**AMENDMENTS TO THE DRAWINGS**

This Amendment is in response to the Office Action dated September 28, 2004.

Application No.: 500.41280X00  
Art Unit: 2879

FIG.1A

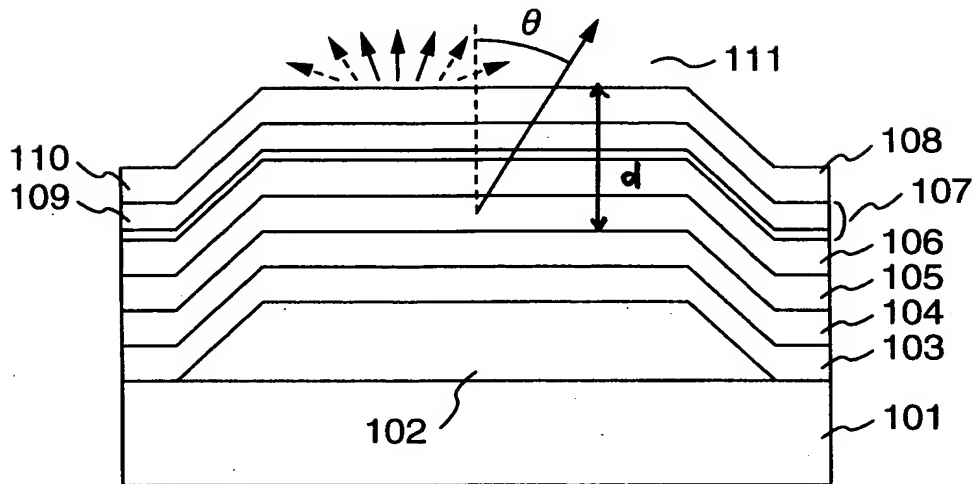
The attached three sheets of drawing includes changes to Figs. 1A, 2A, and 3. These sheets, which include Figs. 1A, 1B, 2A, 2B and 3, replace the original sheets showing Figs. 1A, 1B, 2A, 2B and 3. In Figs. 1A, 2A and 3 a line showing the dimension "d" as discussed on page 15, line 20 et seq. is provided in response to the requirement to do so in paragraph 2 on page 2 of the Office Action.

In addition, the present Amendment also shows the distance "d" in Figs. 1A, 2A and 3, corresponding to the discussion on page 15, line 20 et seq. of the specification, as required in the Office Action. Therefore, removal of the objection to the drawings is also respectfully requested.
